Service Information Bulletins

1997

GRUNDIG
made for you

Colour television receivers with Digi Basic chassis, e.g. ST 70-255 IDTV/LOG, M 70-280 IDTV/LOG, SE 7089 IDTV/LOG

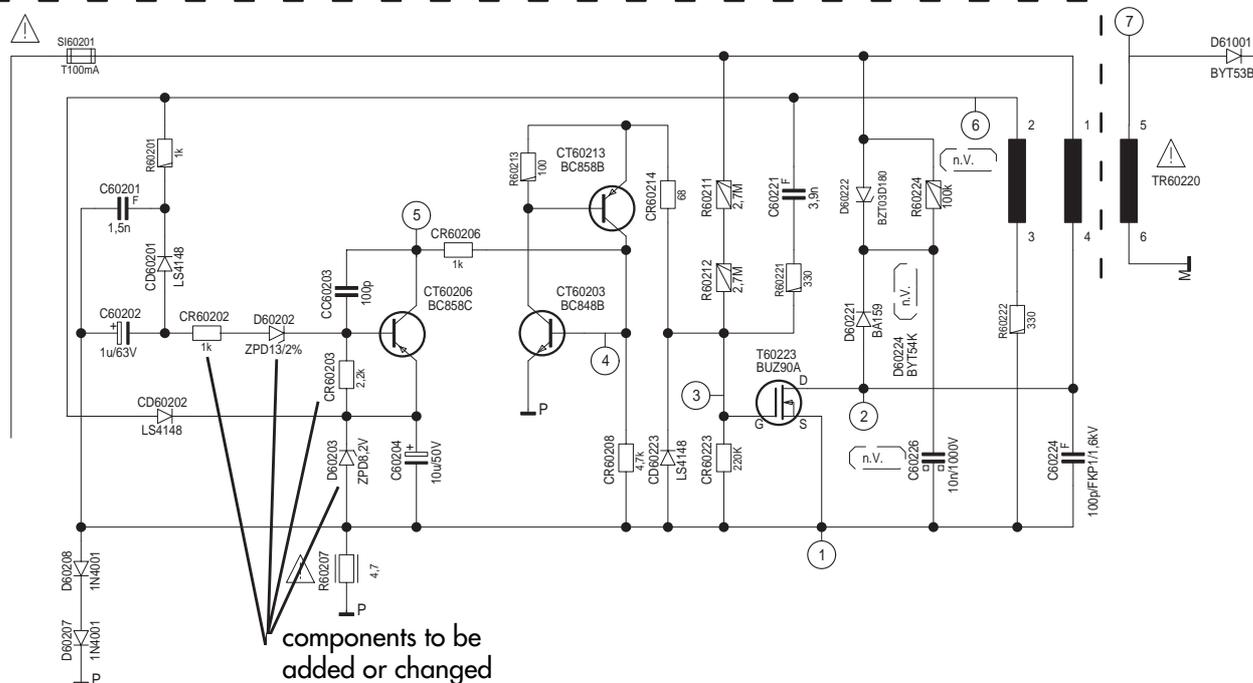
Brown colouration of the circuit board near the diode D 60222 BZT 03D180. Simultaneously the "+Eco" voltage is approx. 5V too high.

Coincidence of unfavourable component tolerances.

Carry out the following changes in the stand-by mains stage:

- Change the Z-diode D 60203 from ZPD 9.1V to 8.2V.
- Change R 60202 from 68 kΩ to 1 kΩ.
- Connect an additional Z-diode ZPD 13 in series with R 60202. Connect the cathode of the diode to the base of the transistor CT 60206.
- Check the rating of the resistor CR 60203 to be 2.2 kΩ.

Portable mono TV/VCR combination TVR 3701 SV

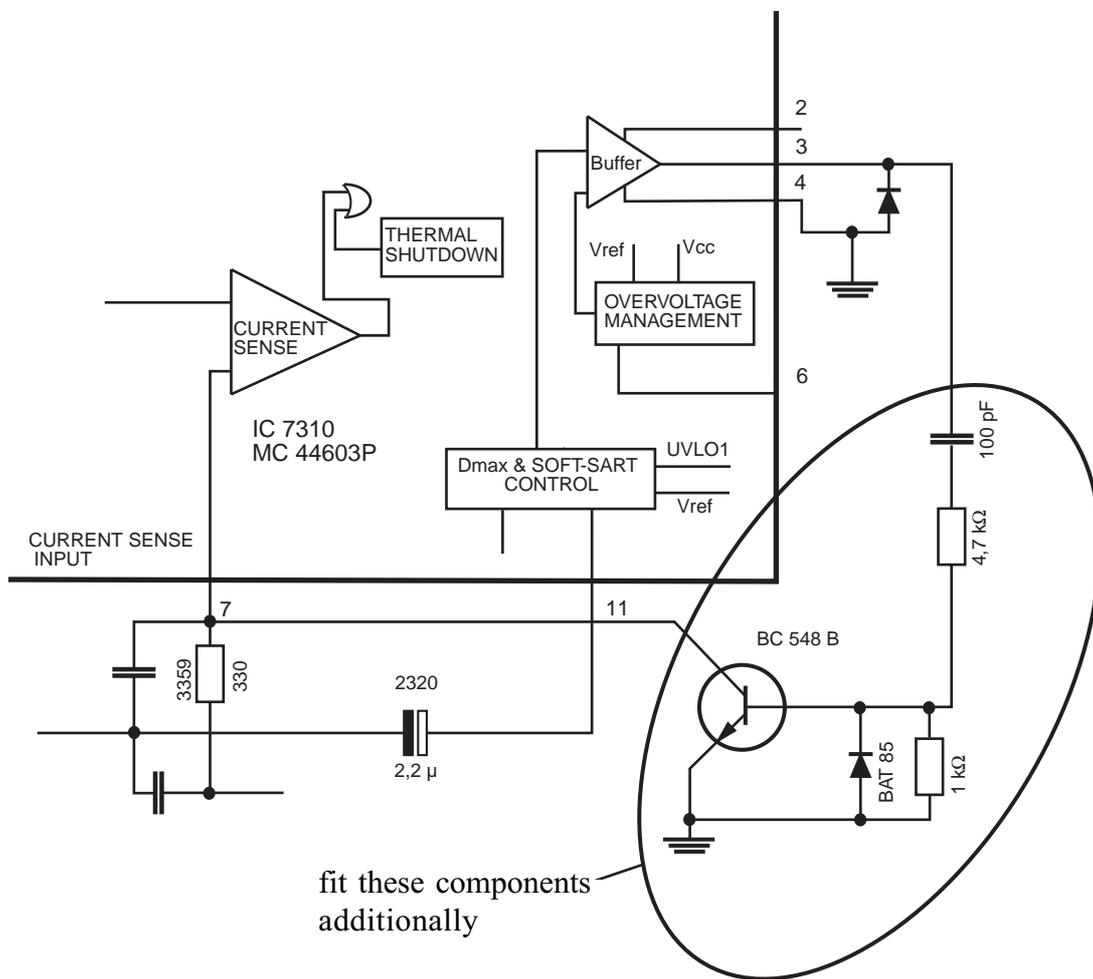
Mains voltage dependent chirp audible in stand-by mode.

Fit an additional transistor stage as shown below into the power supply unit at IC 7310 (MC 44603 P).

37 cm colour television receivers with chassis CUC 7301 text e.g.: P 37-730 text

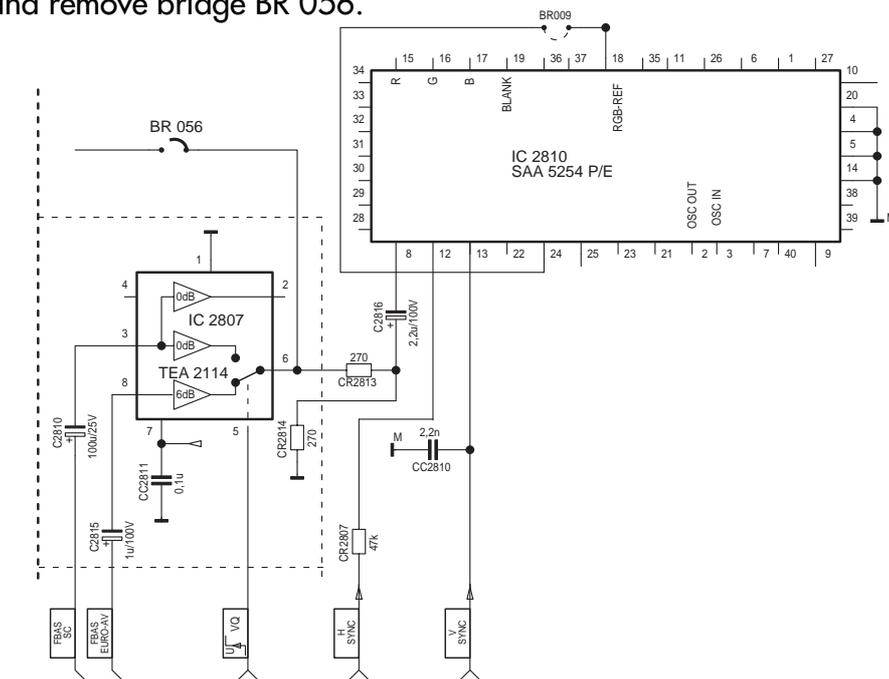
Teletext operation is not possible in "AV" programme position.

The video switch-IC 2807 (TEA 2114) is not fitted in 37 cm television receivers.

Retrofit the following components:

- IC 2807 TEA 2114
- C 2815 1 μ F
- C 2810 100 μ F
- C 2811 0.1 μ F
- CR 2813 270 Ω
- CR 2814 270 Ω

In addition, change the polarity of 2.2 μ F electrolytic capacitor C 2816 (negative terminal to pin 8 of IC 2810) and remove bridge BR 056.

Product **Colour television receivers with chassis CUC 7350, e.g. ST 55-750 text**

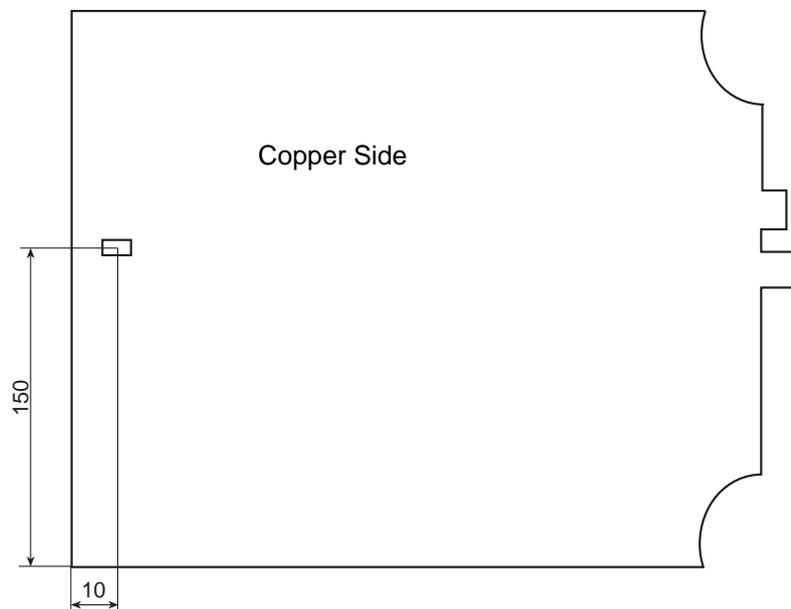
Despite the modifications carried out according to our TV Service Information 9/96 the television sets switch occasionally to Standby after a prolonged time of operation.

Temperature drift of the +E operating voltage by about 0.2 to 0.3V caused by Z-diode CD 61023. Consequently, IC 34015 TDA 8374 switches off with sudden black/white changes in the picture content or changing scenes.

This Z-diode has been introduced later and therefore is drawn in only in the 1st Supplement to the CUC 7350 Service Manual.

The position of the Z-diode is X=10, Y=150. Unsolder this diode and insert a SMD resistor 1206 1.2Ω 1% in this place.

Product Colour television receivers with chassis CUC 7300, e.g. P 37-740 SAT, and all sets retrofitted with the built-in satellite receiver SER 7300

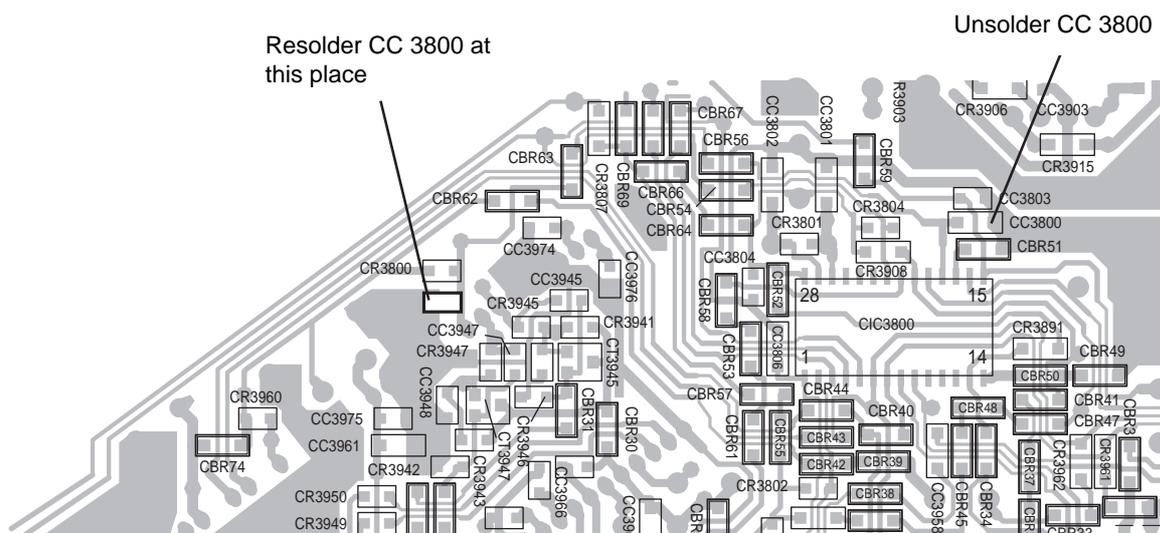
The sound disappears suddenly during the reception of a satellite programme and is audible again only when changing the programme or switching the TV off and on again.

IC MSP 3400 on the SAT Module hangs up by static charges entering the Reset input of the IC.

Unsolder the SMD capacitor CC 3800 from its place on the SAT Module and resolder it at the place indicated on the figure below.

Product **Colour television receivers with chassis CUC 7303/7305/7350 and the picture tube panels 29305-022.16/-022.17, e.g. P 37-731 text, P 45-731 text, T 55-731 text, P 37-731/12 text, ST 55-750 text, XS 55/1, Lissabon SE 5576 text**

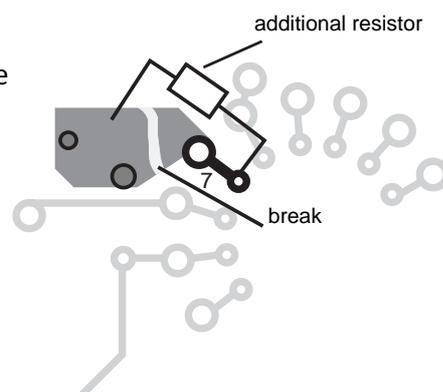
Failure of the RGB output stages (picture tube panels 29305-022.16 and -022.17) or of the teletext function.

The semiconductors are destroyed by high-voltage sparks within the picture tube.

On the picture tube panels -022.16/-022.17, insert an additional 1.5 kΩ composite carbon resistor (do not use a carbon film resistor!) into the circuit path to the screen grid connection of the picture tube socket. Ensure that the break is 2mm wide at least (see figure) to avoid sparking.

Product **Colour television receivers with Digi 6 chassis CUC 1842, 1894, 1952, 1962 and 1983, e.g. M 72-410 Ref., Denver SE 8216/9 PAL Plus, M 70-269/9 Ref.**

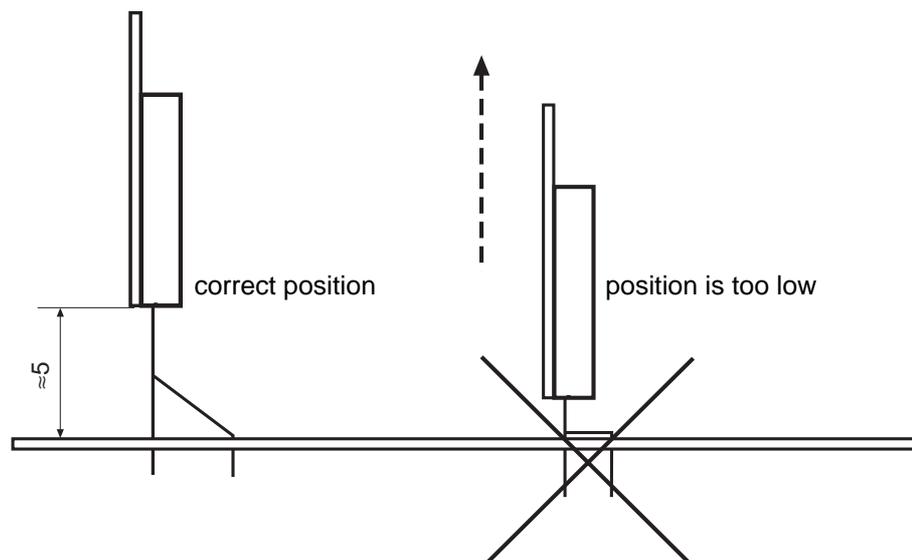
Vertical output stage TDA 4173 fails or thin white lines similar to retrace stripes are visible.

Inherent instability of the vertical output stage IC TDA 4173 AF.

- Should above mentioned symptoms appear do not fail to exchange TDA 4173 AF and solder additionally a 1 nF foil capacitor from pin 1 and from pin 7 each to pin 4 (-K voltage) on the copper side.
- Check the mounting position of the vertical output-IC. If the position of the IC is too low, the pins may temporarily come into contact with the chassis connection on the upper side causing the IC to fail. Additionally, the circuit may already be damaged by the building up force of pressure resulting in a long-term failure. Therefore replace TDA 4173 AF also if it has not been fitted correctly!

Product Colour television receivers with Digi Basic chassis - CUC 1806, 1825, 1826, 1827, 1829, 1830 with the picture tube panels 29305-122.04/-122.10/-122.12 and -122.17
 e.g. ST 70-255 IDTV/LOG, ST 72-261 IDTV/LOG, Atlanta SE 7220 IDTV/LOG, ST 72-261 IDTV/LOG

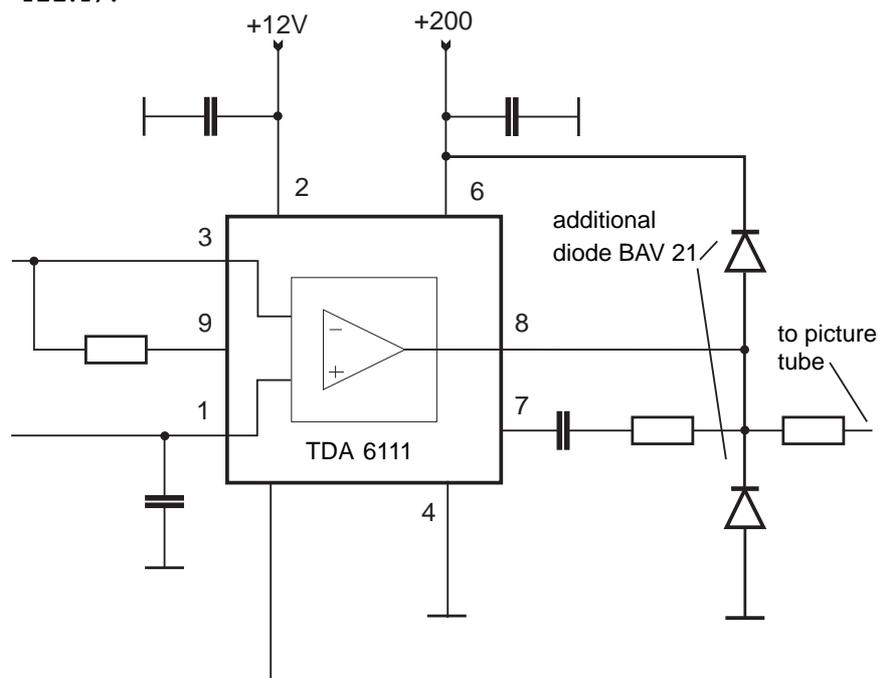
Failure of the RGB output IC's TDA 6111.

The RGB output IC's are destroyed by high voltage sparks.

Directly from the outputs (pin 8) of the three output IC's TDA 6111 connect one additional diode BAV 21 each to chassis and one diode each to the +200 voltage (see figure).

The insertion of the three diodes which are to be connected to +200 is already prepared on the picture tube panel by the diodes D 734, D 754 and D 774.

The three diodes which are to be connected to chassis are to be soldered on to the copper side from pin 8 to pin 4 (anode to pin 4).

Product **Series GV 4xx video recorders with „World Deck“**

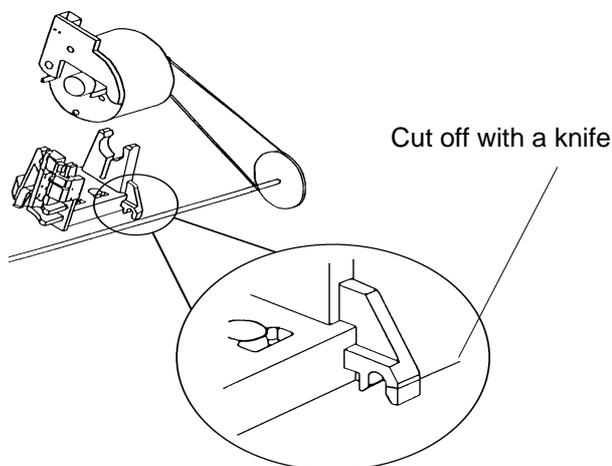
Drive mechanism does not move.

Slipping of the bevel gear of the pulley shaft (pos. 47) and / or worm shaft (pos. 48).

Replace the pulley shaft and / or worm shaft.

To replace the pulley shaft quickly follow the instructions given below: Dismantle the drive mechanism, set the drive mechanism to EJECT position, remove the cassette compartment, remove the threading belt, detach the worm shaft and the pulley shaft, **cut the motor holder with a knife as shown on the figure below**, pull out the pulley shaft, fit and snap in the new pulley shaft and worm shaft, refit the cassette compartment as described in the Service Manual.

Product **GV 660 / GV 690**

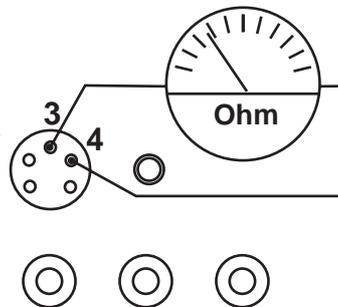
Master/Slave and Synchro Edit control functions do not work.

In a small number of GV 660 and GV 690 video recorders, the 7-pin cable (pos. 9511) from the keyboard control unit to the teletext module is not inserted correctly (laterally inverted) on the keyboard control unit.

Disconnect the 7-pin cable from connector 1511 on the teletext module, turn it by 180 degrees and refit it.

Circuit extract:
Chassis Board - Head Amplifier
Service Manual 72010-530.25
page 4 - 30

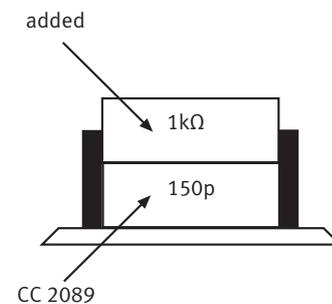
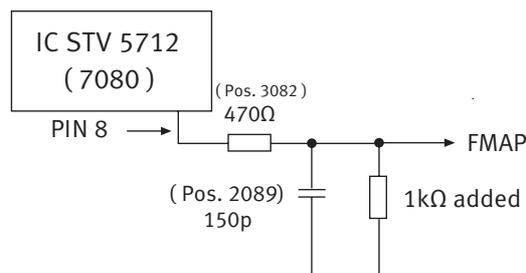
Disturbances and noise along with the HIFI sound.

No steady audio-FM signal identified on playing back.

Carry out the following changes on the chassis board - head amplifier.

1. Change CR 3082 from 100Ω to 470Ω.
2. Change CC 2089 from 220p to 150p.
3. Add CR 1kΩ to CC2089.
